June 18, 2025

# ADDENDUM # 1

# RFT-SM-006-25 – Glencoe Wastewater System Upgrades – Victoria Street Sewage Pump Station Upgrade

# PLAN ABOVE EL 219.320

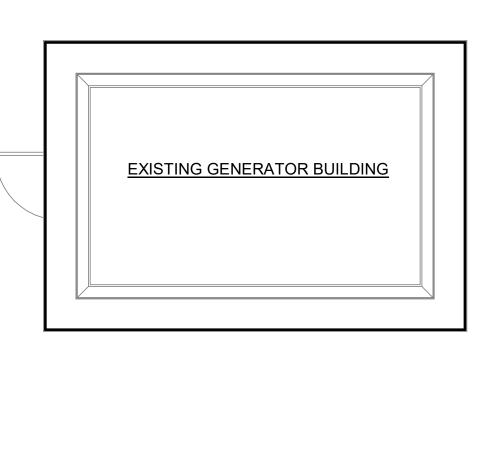
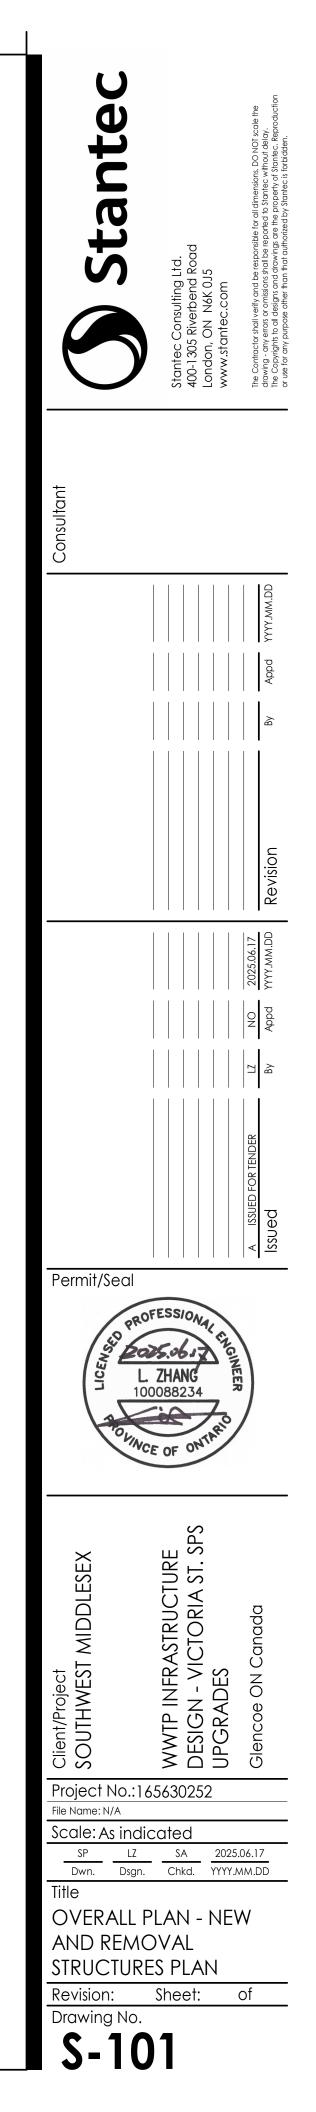
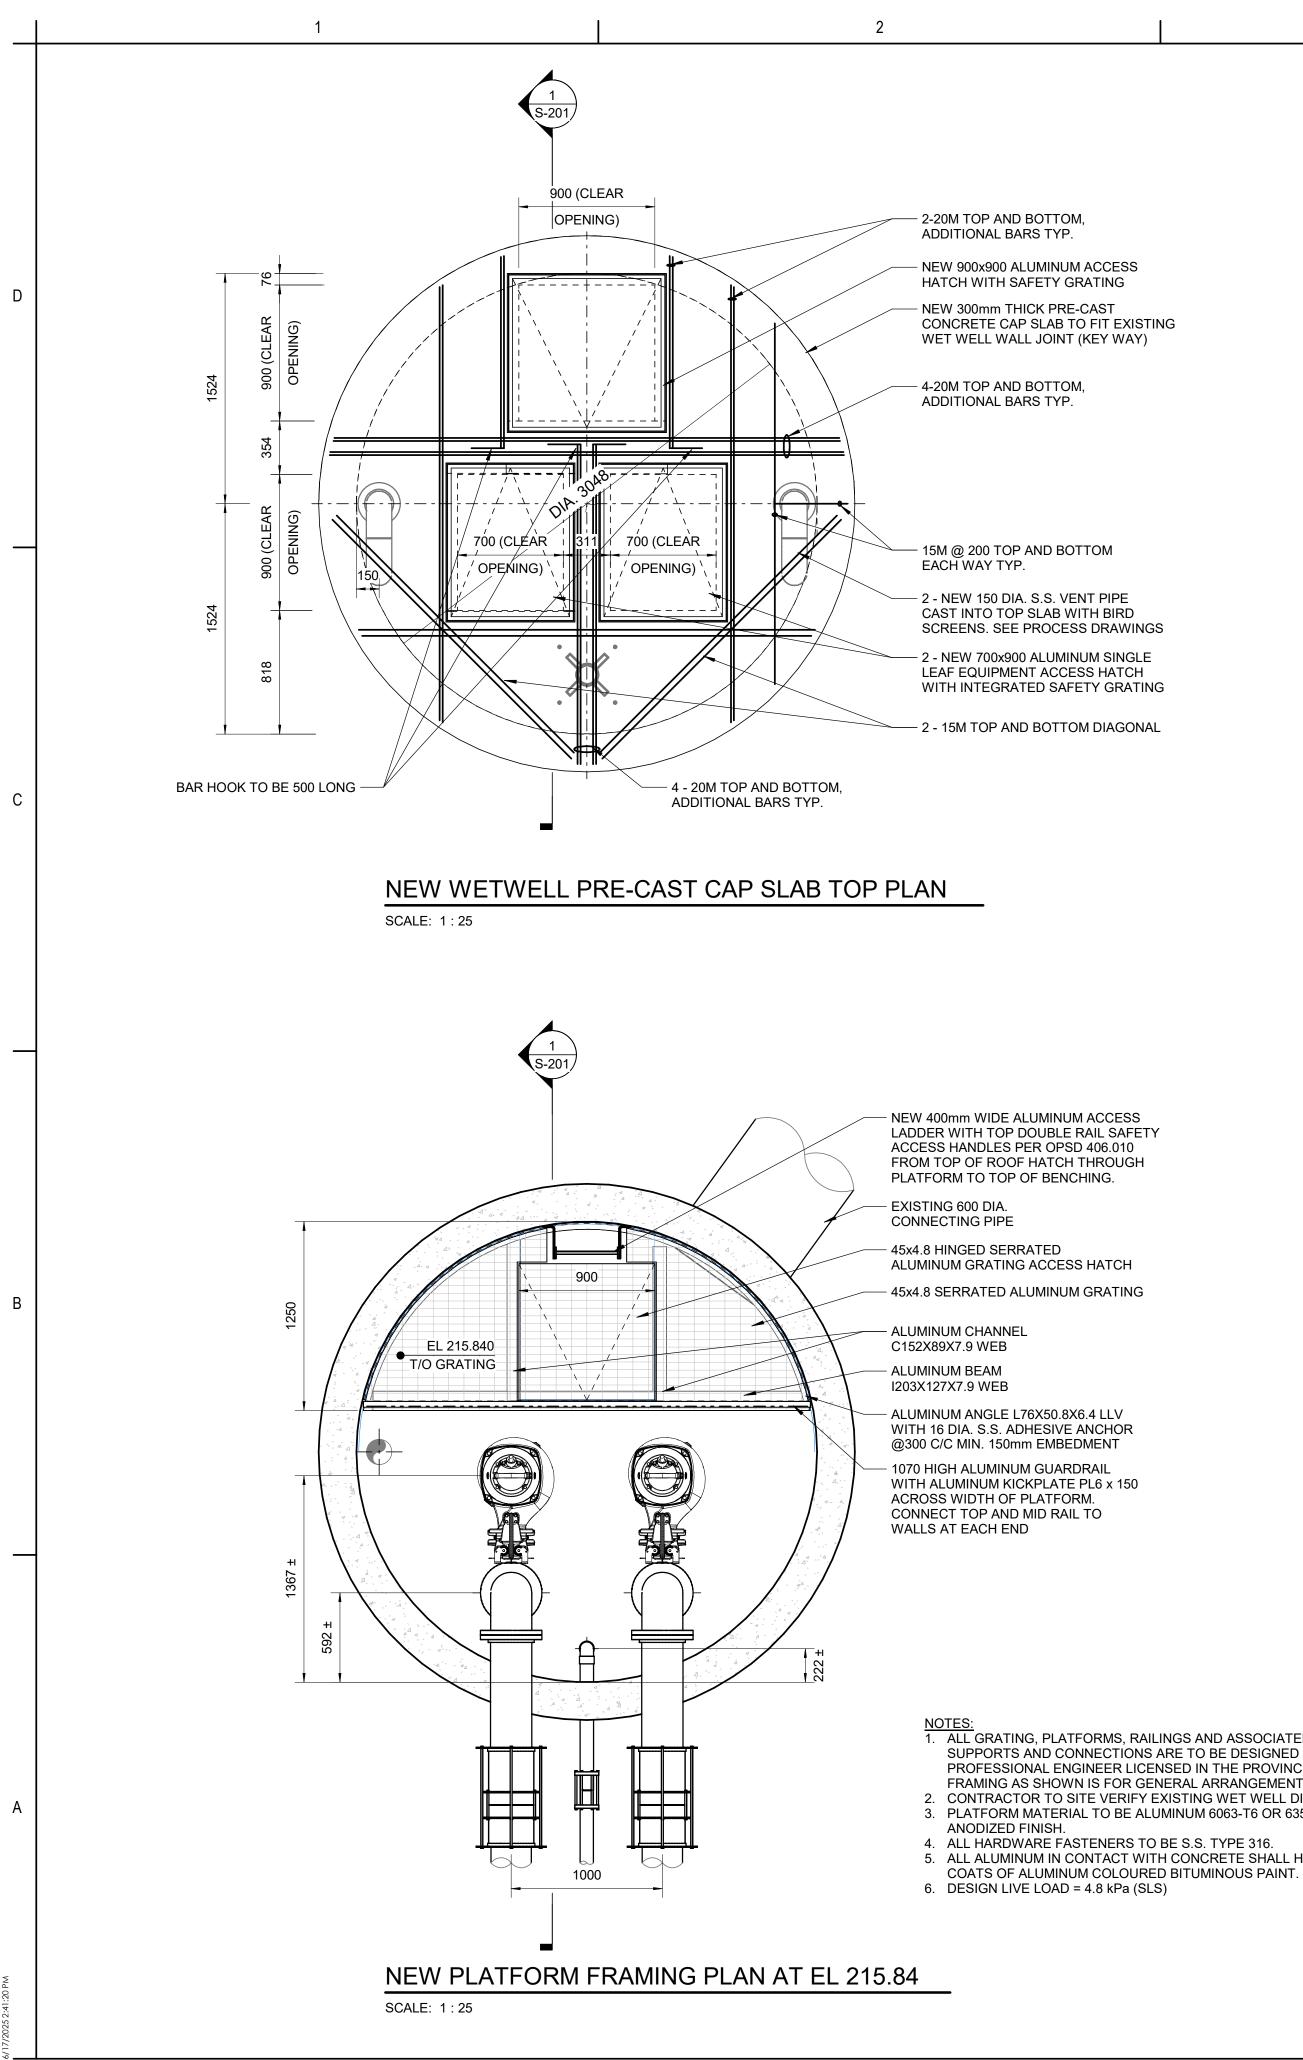
EXISTING VALVE CHAMBER TO BE USED FOR TEMPORARY

PUMPING AND THEN ABANDONED

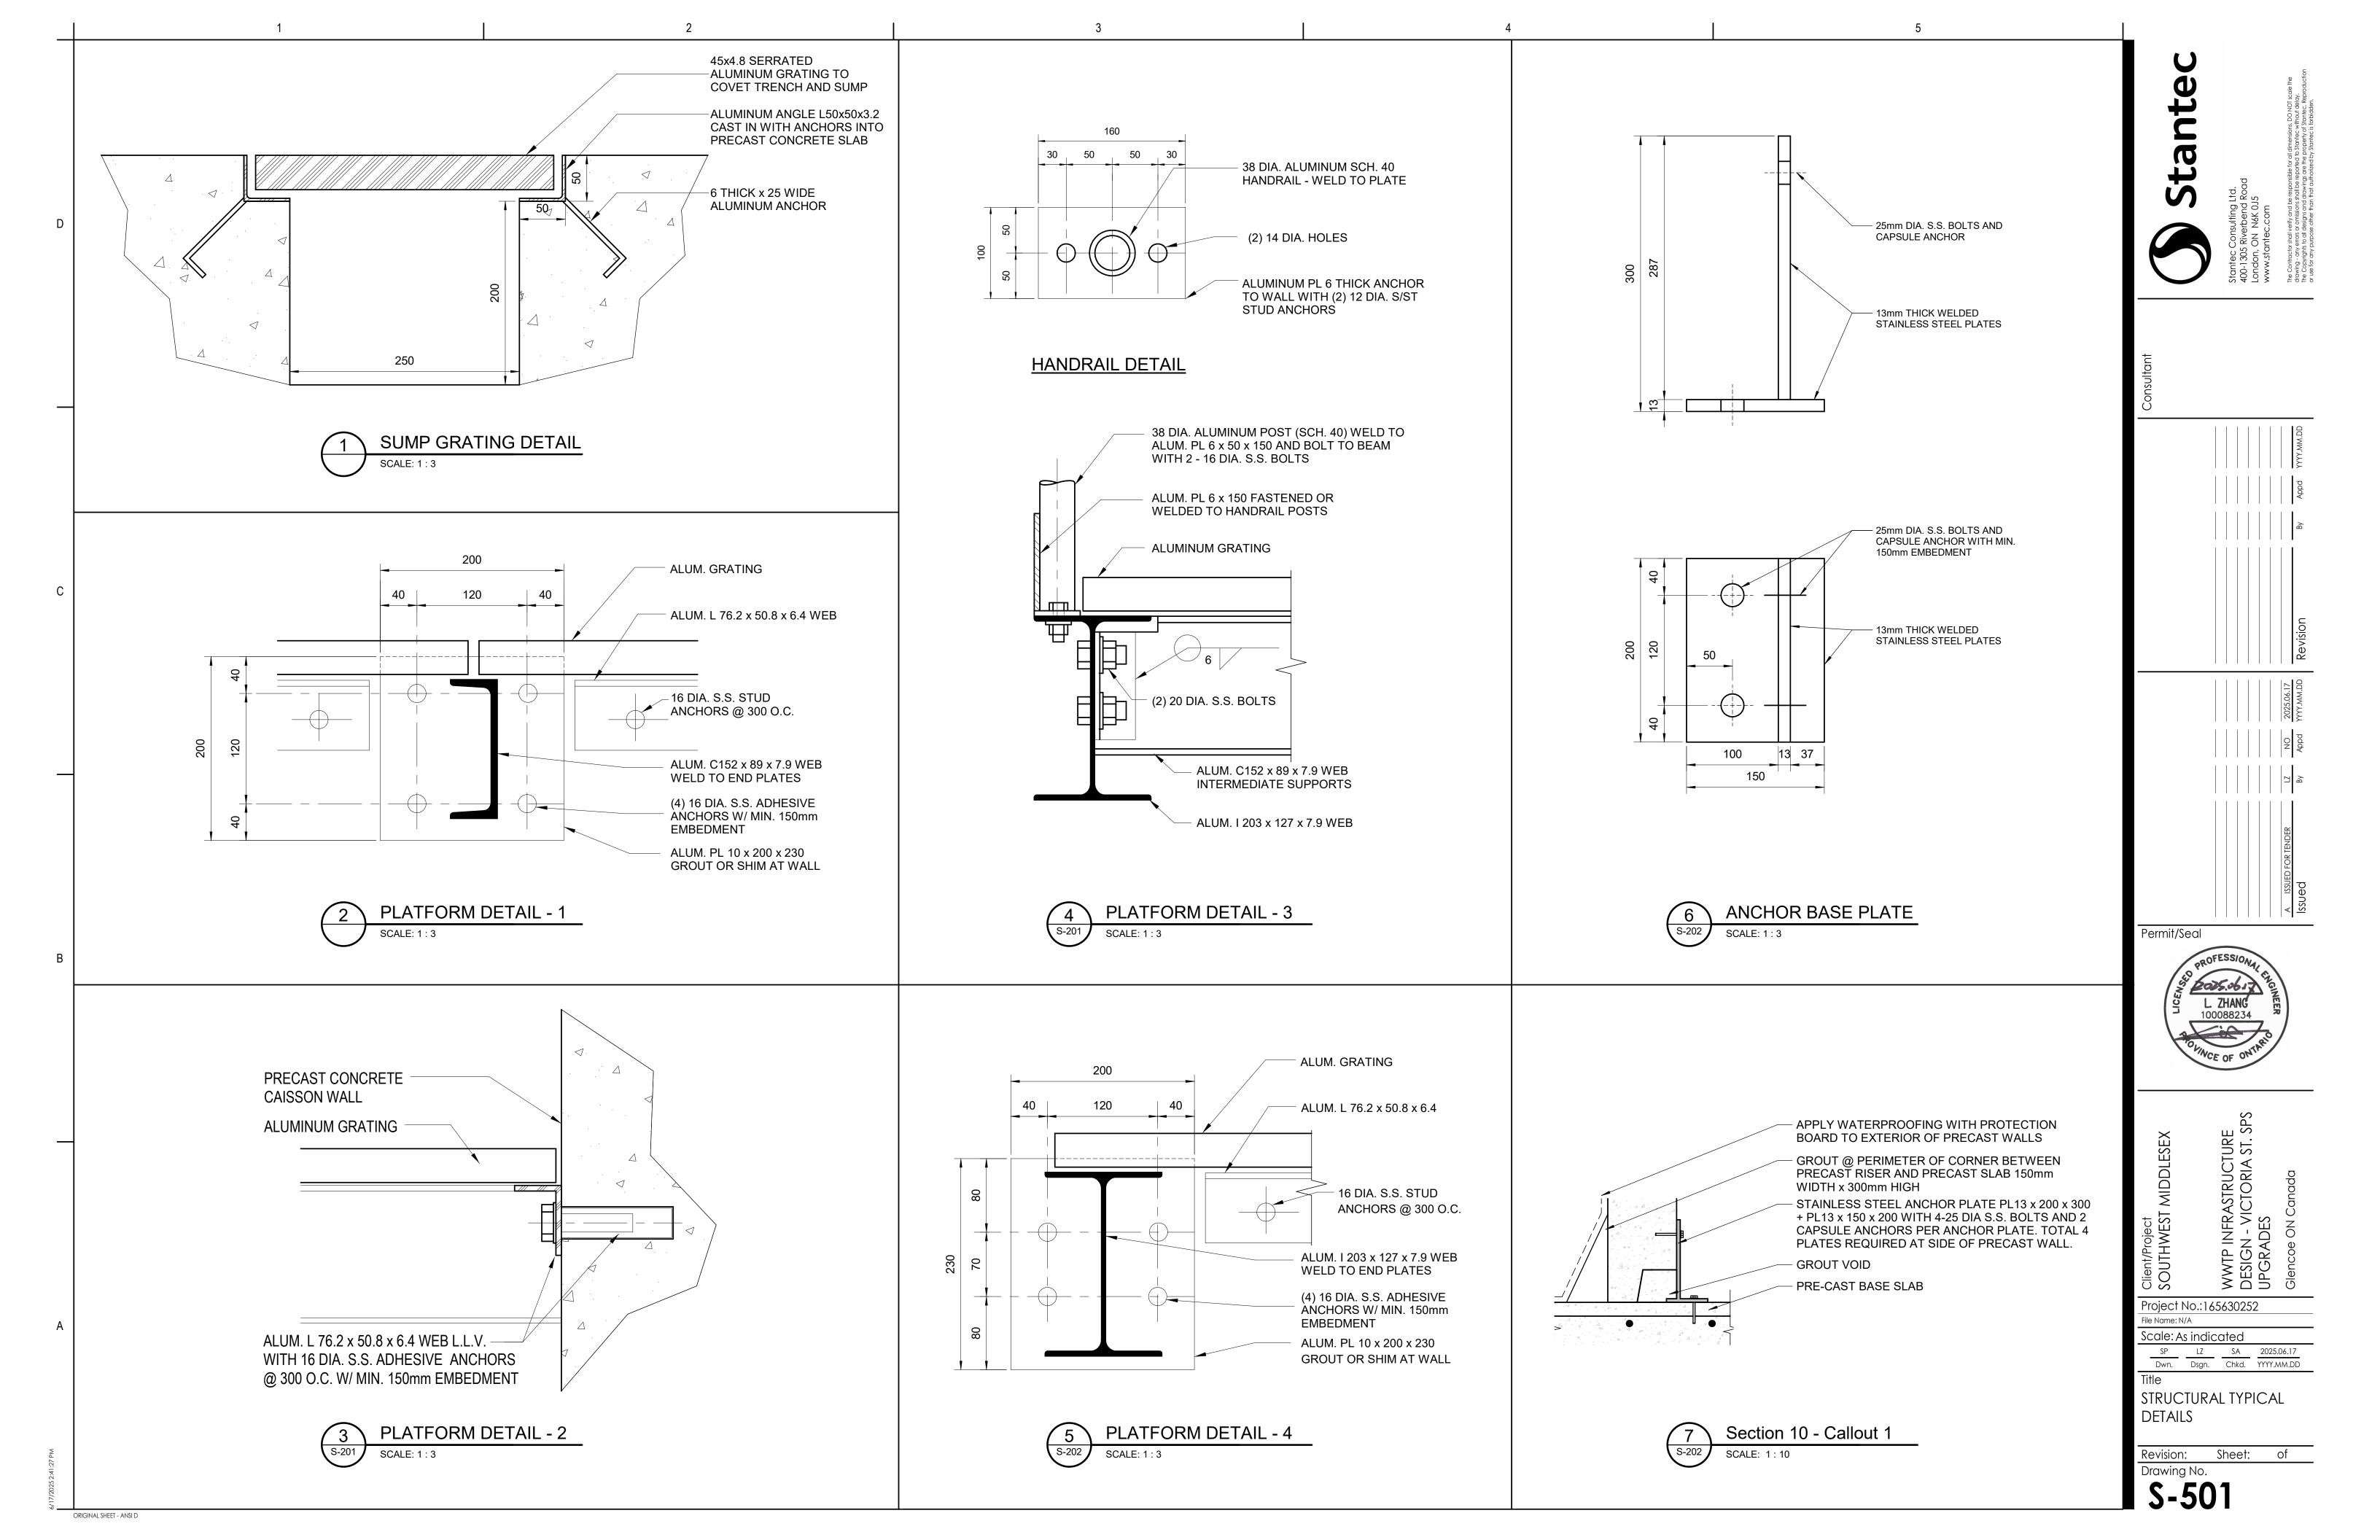
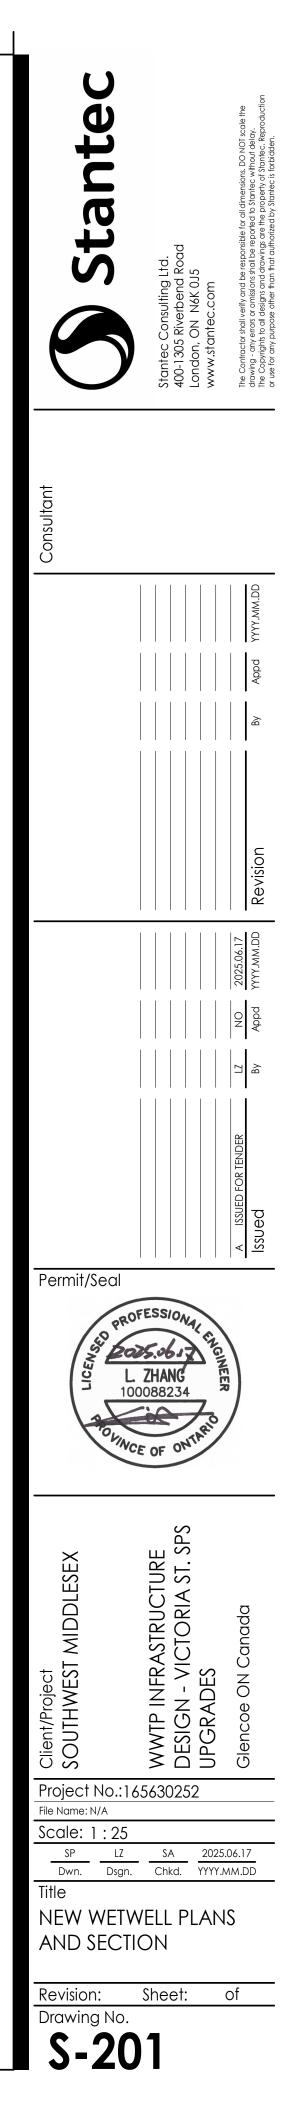
**Question 23:** On Page DP-103, there is note on the existing Wet well for the platform and ladder etc., are these to be replaced?

**Answer 23**: Correct, the platform/lid and ladder are to be replaced. Please refer to additional drawings S-101, S-201, and S-501.
